Re: S/D 91-12 (Final Plat) Elizabeth's Addition

STAFF REPORT
(Final Plat)

CASE NUMBER: S/D 91-12 - ELIZABETH'S ADDITION
OWNER/APPLICANT: Lee V. Luinstra, etux, 137 Rice Drive,
Wichita, KS 67042
SURVEYOR/ENGINEER: Baughman Company, 315 Ellis, Wichita, KS
67211
LOCATION: SW corner of 21st St. North and Hillside Ave.
SITE SIZE: .7 Acres
NUMBER OF LOTS
Residential:
Office:
Commercial: 1
Industrial:
Total: 1
MINIMUM LOT AREA: 28,508.6 sq. ft.
CURRENT ZONING:
PROPOSED ZONING:

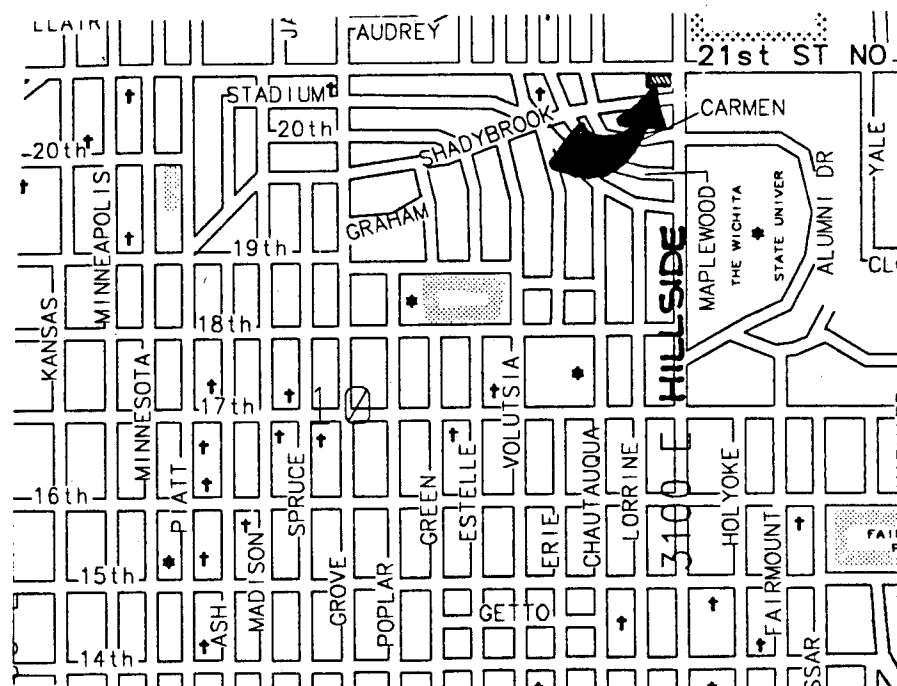
The enclosed "marked" copy of the final plat is for your information and files.
